Environmental Review Team Report

Assawogga Heights

Killingly, Connecticut

April 1978

FOREST STANDS

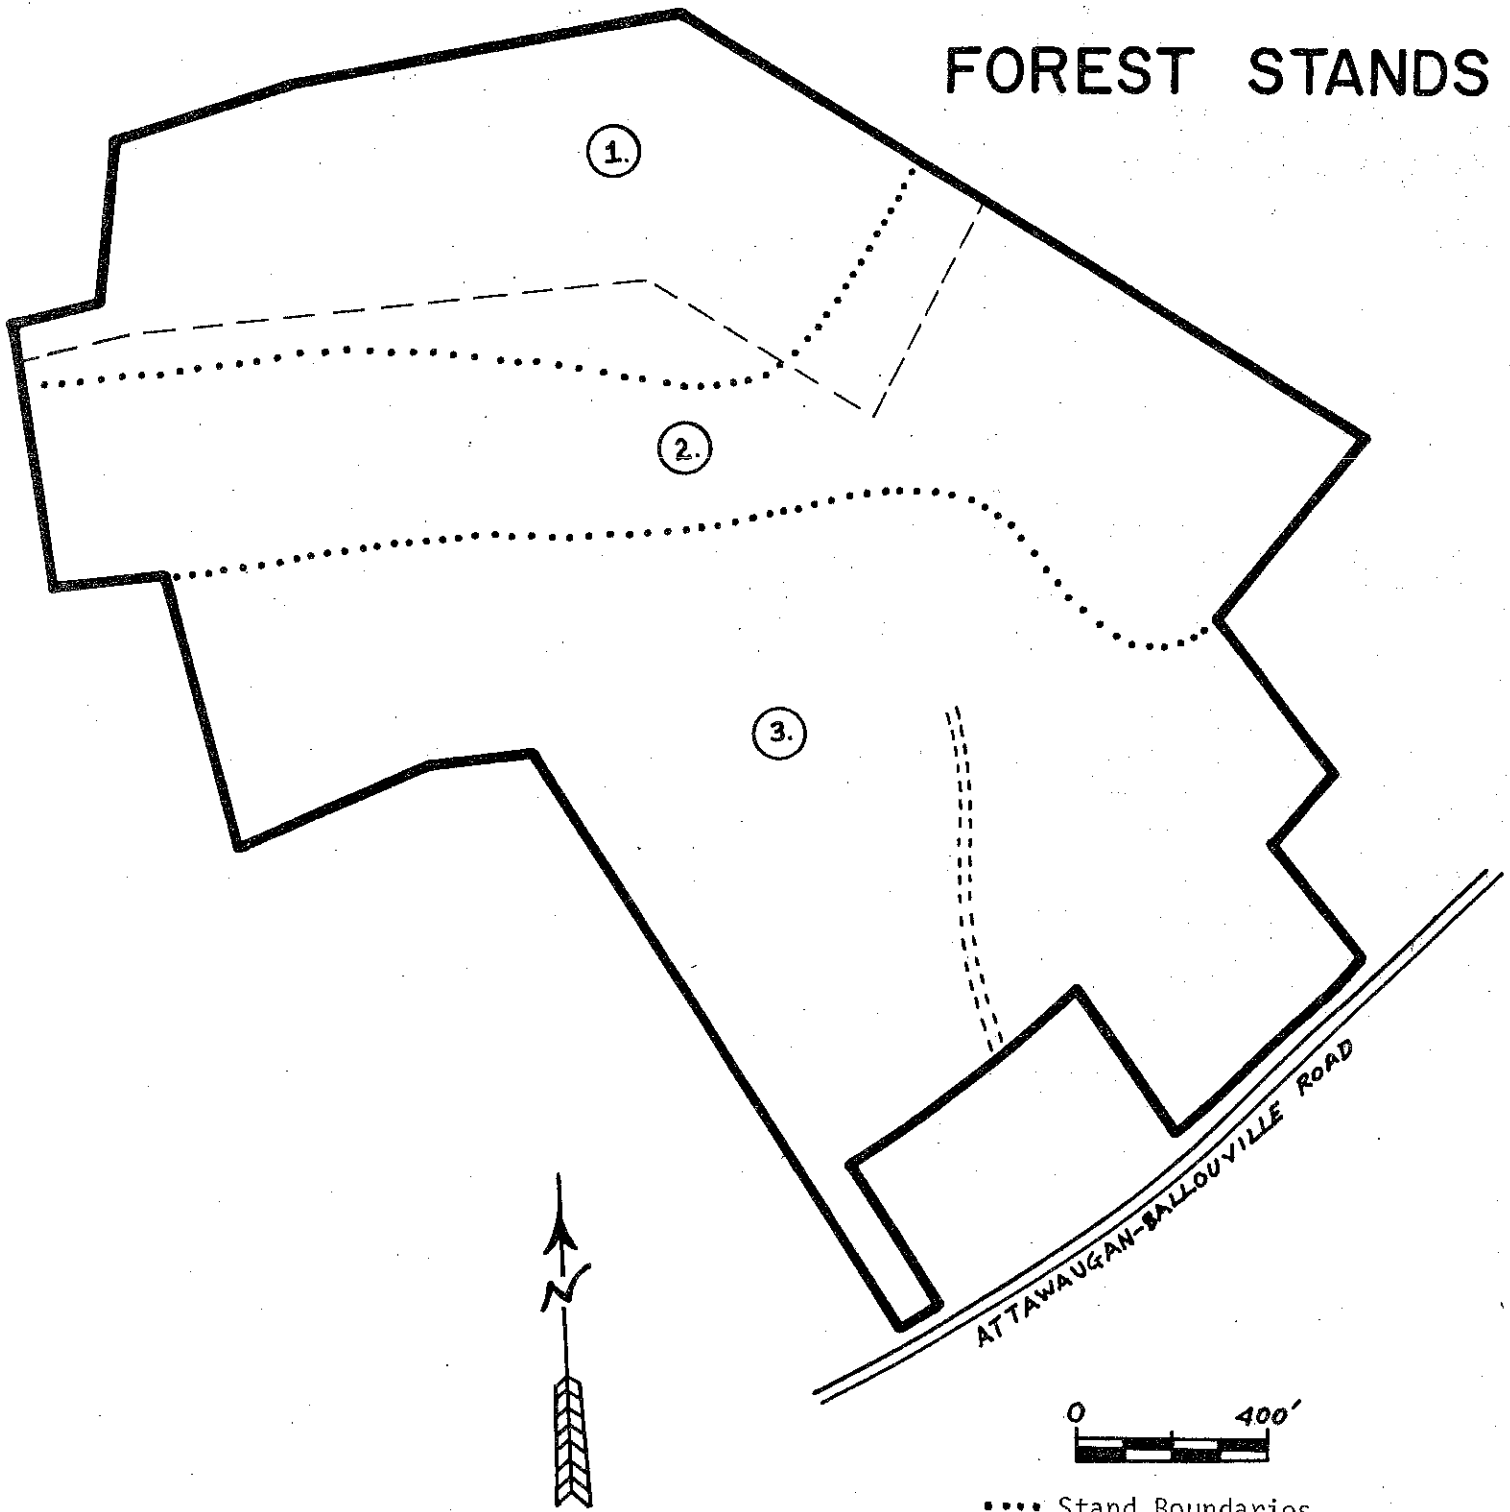
The site of the Assawogga Heights subdivision can be divided into three forested stands. These areas are illustrated on the accompanying map.

Stand One: This area consists of approximately 5.5 acres, with white pine as the dominant species. Red oaks, red maples and other hardwoods of poor quality are also present. Some forest reproduction, in the form of white pine is evident, but sparse. It is recommended that there be a cordwood harvest in this stand to increase white pine reproduction and to remove hazardous dead and dying trees which had been affected by the gypsy moth infestation several years ago. The probable yield of this cordwood harvest would be 8 cords.

Stand Two: This stand is approximately 7 acres, also with white pine as the dominant species. Other species which are present include birch, cherry, oak and red maple. Seventy-five percent of the reproduction in this area is white pine. There are no live stems over 4" DBH (diameter of trunk at breast height) in this area and there are many dead standing trees from 12 to 18" DBH which represent a hazard. A cordwood harvest, yielding approximately 21 cords, to eliminate all dead and dying material is suggested for this section of the site.

Stand Three: This 11.5 acre area is dominated by red maple. The area is overstocked with sapling to pole size red maple, oak and white pine. There is very little evidence of reproduction in this stand with the exception of red maple saplings. A cordwood harvest of all dead and dying materials is also recommended for this area, with a probable yield of 11 cords.

POTENTIAL FLOOD ZONE

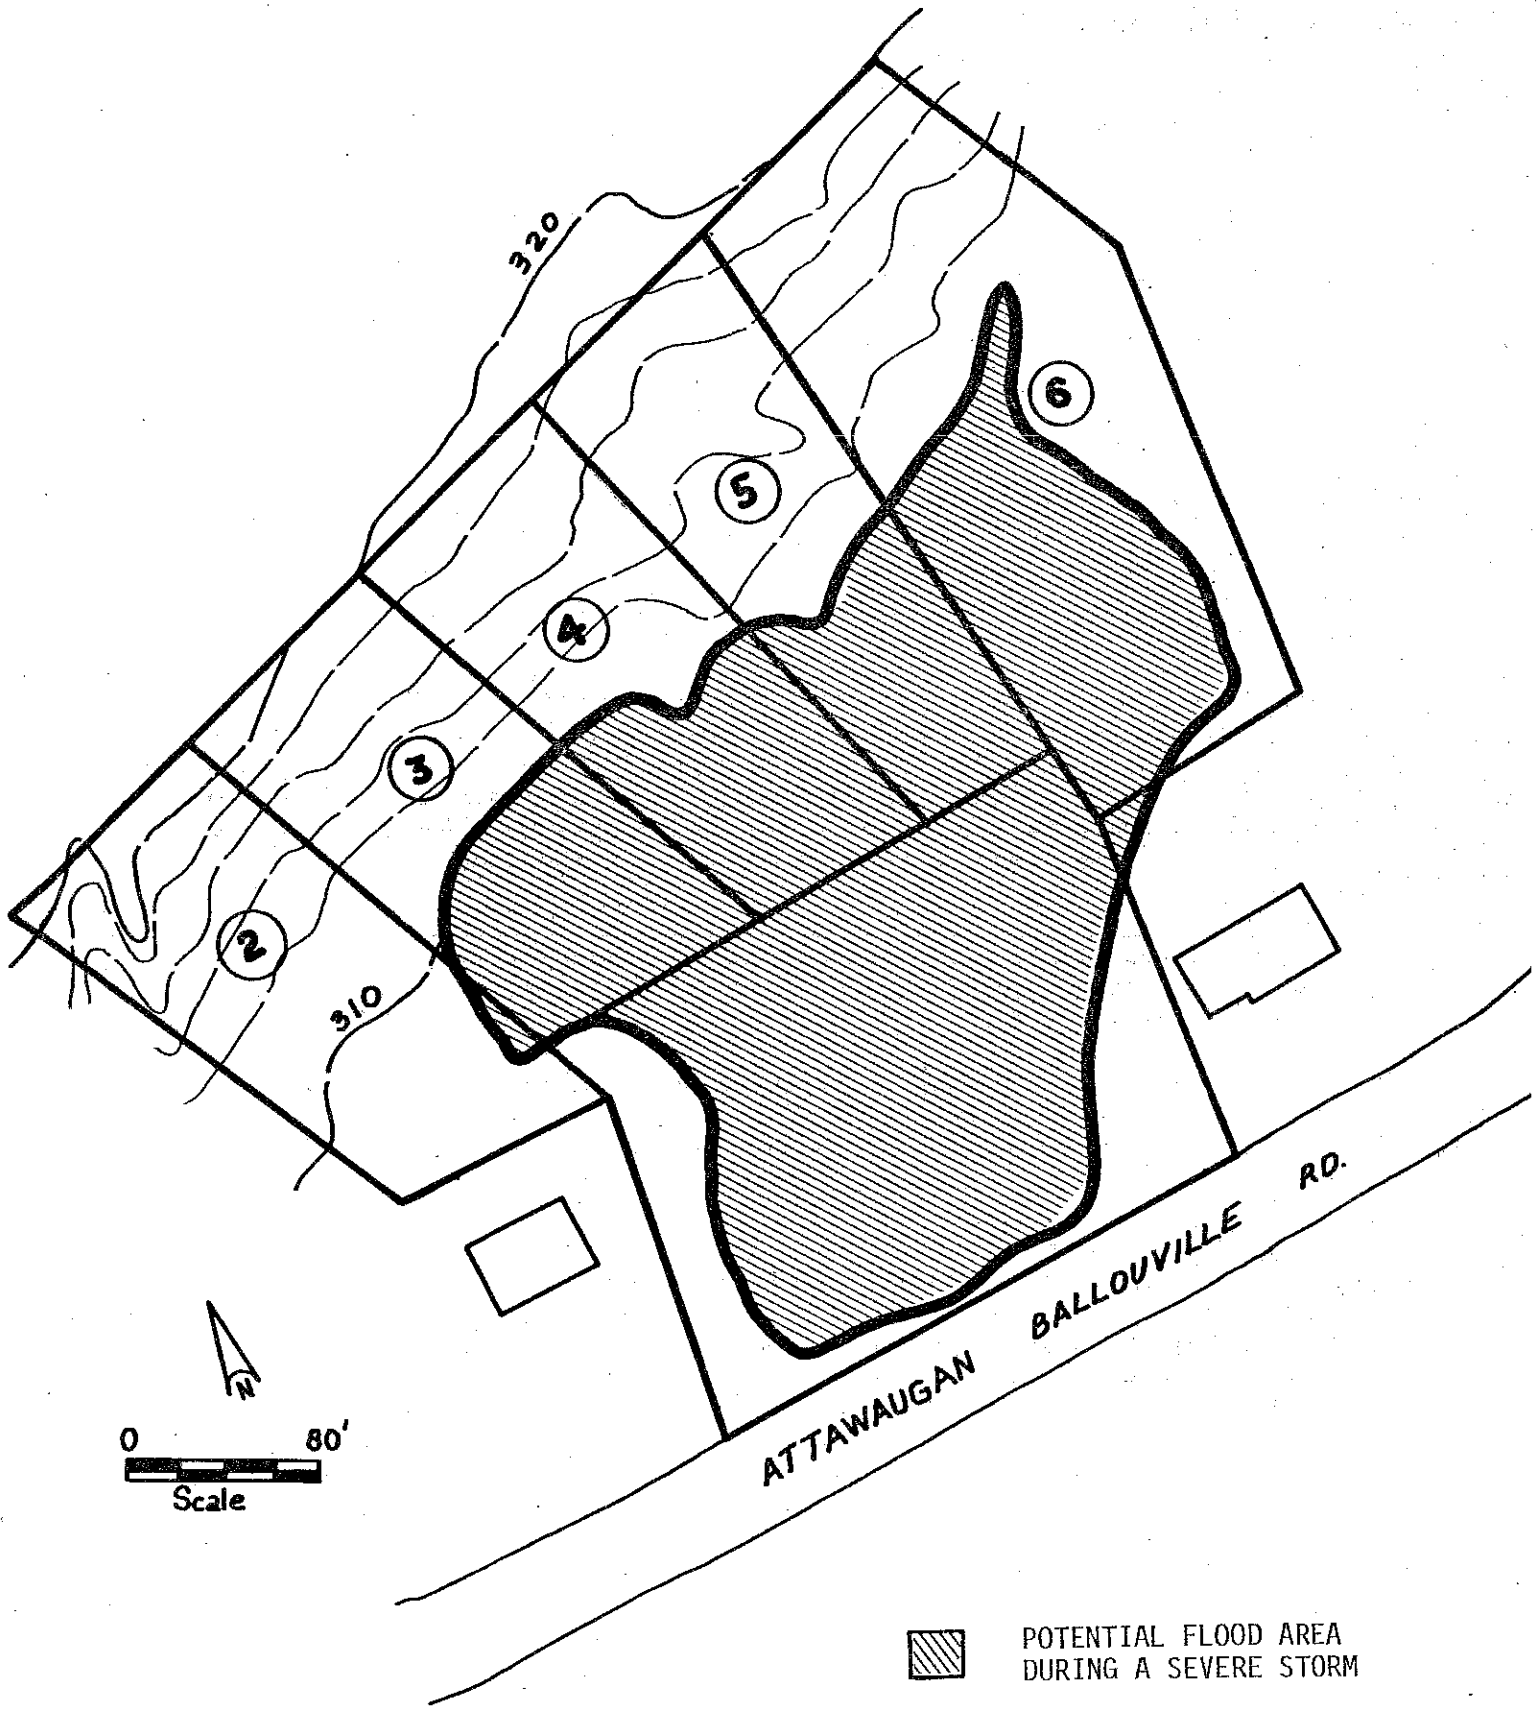
As the soils limitation chart in the Appendix shows, approximately 39% of the site is in Canton-Charlton soils, 22% of the site is in Charlton-Hollis soils, 27% is in Sutton soils and 8% is in Scarboro soils which are regulated wetlands under Public Act 155. By comparing the subdivision plan with the soils map of the area it appears that Lots 4, 5, 6, 7, 9 and also Lots 23, 24, and 25 may lie within Sutton soils which are stony, seasonably quite wet. These soils are also severely limited for buildings with or without basements. Portions of Lots 5 and 6 appear to lie within Scarboro soils which are regulated wetlands. As shown in the accompanying illustration the rear of Lots 3, 4, 5, and 6 is also subject to flooding during a severe storm from the storm water retention basin. Future property owners should be made aware of these problems before purchasing the property, perhaps by means of a deed restriction, limiting the construction of accessory structures below the 310 contour mark. Owners of Lots 4 and 5 should be aware of the flooding problems which will exist from the storm water discharge pipe which will disperse continually across their property. This outflow should be riprapped to the rear property line to prevent erosion in this area. Erosion control measures should be

considered for use in lots 7, 8 and 9 as the potential gullying from the proposed swale in this area could prove to be a liability to the lot owner and the Town. A drainage easement on Lots 6, 7, 8 and 9 should be deeded to the Town wherein lot owners are required to maintain drainage swales to allow free flow of water. Due to the nature of the slope and soils, the Team feels that some sort of stone-lined waterway would be needed in the swale area of Lot 7. In addition, establishment of grass in this heavily shaded portion of the site could be a problem in this newly cut area.

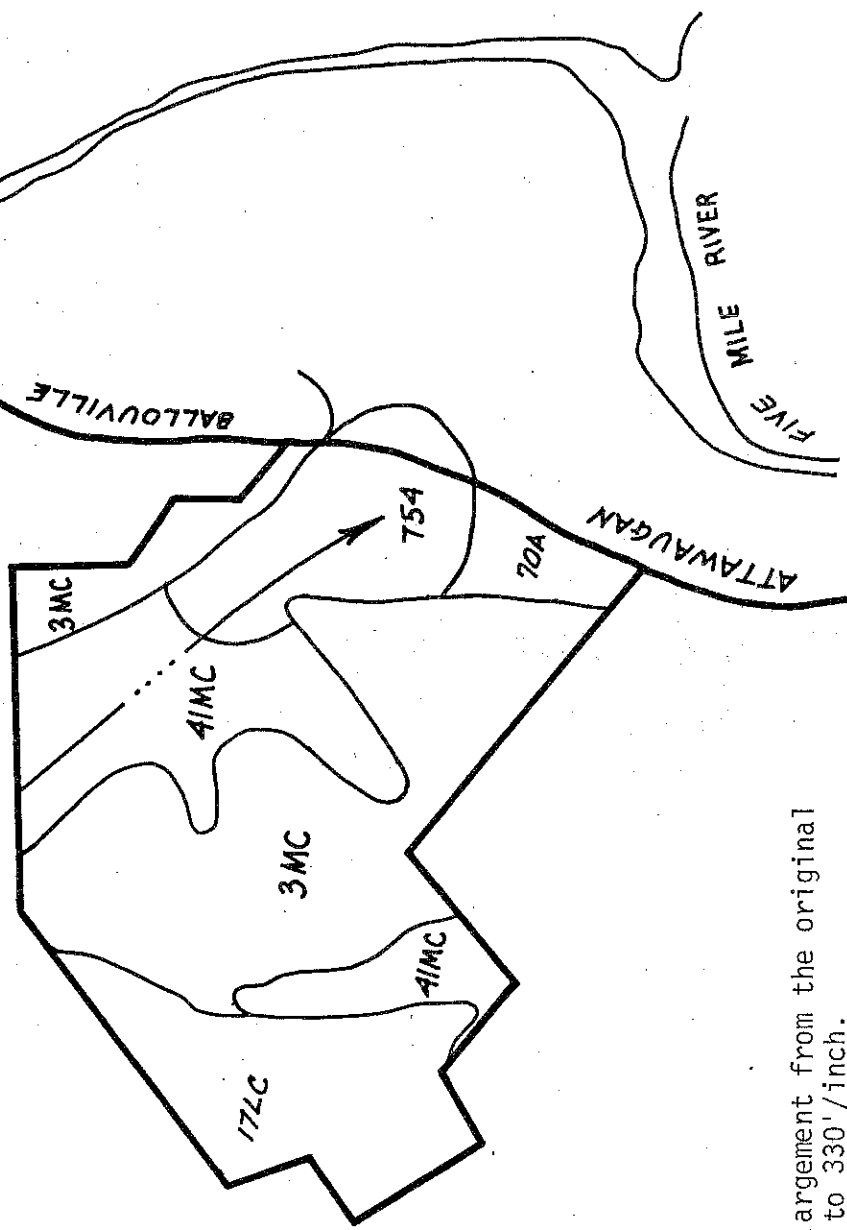
The Team does question, however, the specific five acres which have been designated for open space. As shown on the development plan, the 5 acre parcel is quite steep and susceptible to erosion if the forest floor cover is disrupted or removed. This could happen through trail bike use or improperly designed hiking paths directed up the slope instead of paralleling the contours of the hill. Run-off erosion and gulying could occur, causing problems for houses located down slope from the open space area.

The Town may wish to consider another area for open space in this subdivision which would be mutually agreeable with the developer. The storm water basin and portions of the surrounding area may be a possibility. A pond for swimming, skating, fishing, fire water supply, etc., with picnic tables and a roof shelter may be very desirable for use by the present neighbors as well as property owners in the subdivision. The Town would have easy access to this area, from Attawaugan-Ballouville Road, although there would be no area provided for off street parking.
